Change Order Request

Change Order No.: 24R1

Project: Barfield Highway

Description: Cost to adjust two Fire Hydrants and associated valve stem and collar.

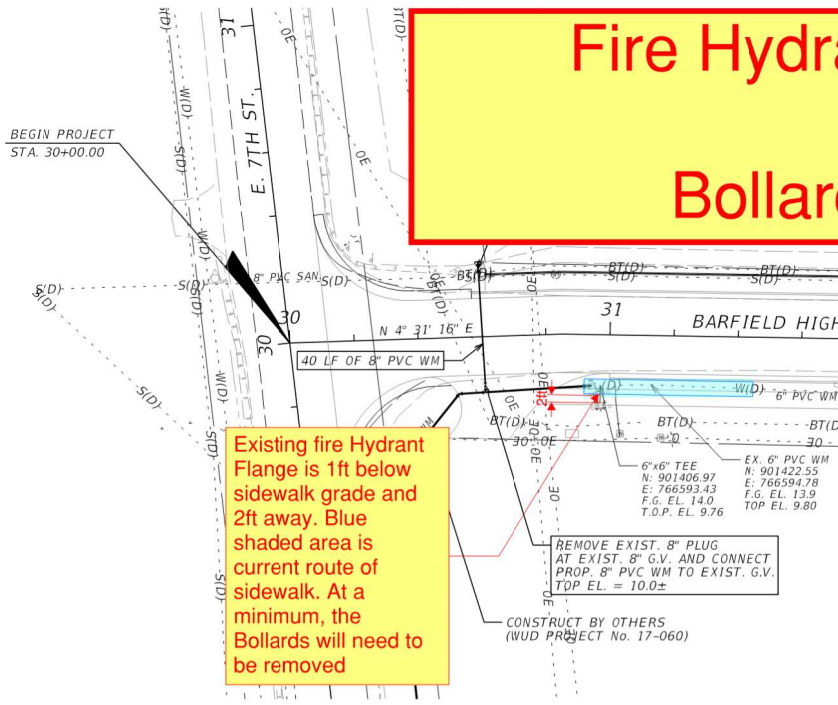
The existing Fire Hydrant Flange shown in the attached is 1ft below sidewalk grade and 2ft away and the bollards will conflict with the installation of the proposed sidewalk. RSD would like to know if the EOR would like to raise/relocate the Fire Hydrant and remove the (2) two Bollards that are in conflict with the proposed sidewalk? The blue shaded area is current route of sidewalk.
Please advise RSD on how to proceed.

See Email thread for response from PBC.

See follow up email 8/15 below on additional FH to be adjusted.

Fire Hydrant Elevation & Bollard Conflict

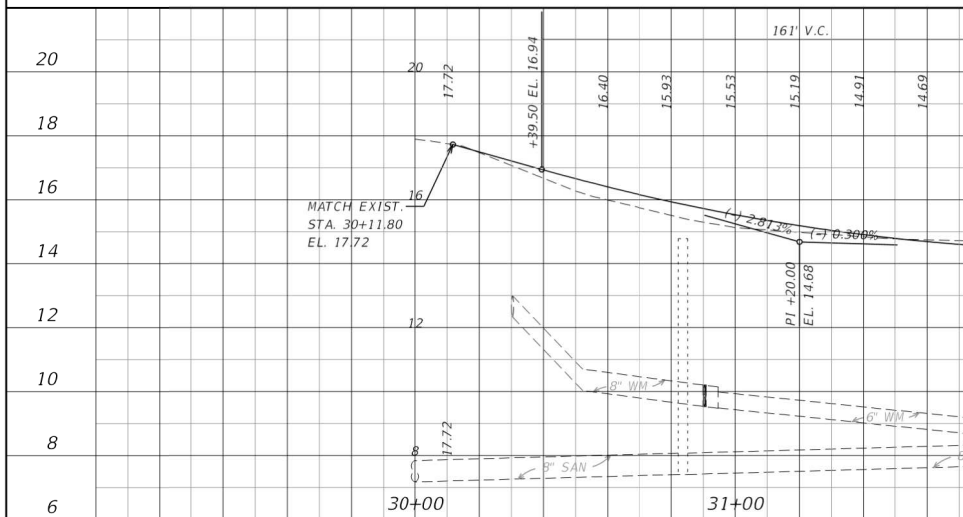
Existing fire Hydrant Flange is 1ft below sidewalk grade and 2ft away. Blue shaded area is current route of sidewalk. At a minimum, the Bollards will need to be removed

We haven't verified yet the FH at sta 35+40 but for FH at sta 31-/+ please do the following:

- The FH will need to be raised.
- Bollards to be removed.
- See attached record drawings, the existing valve boxes to be adjusted.
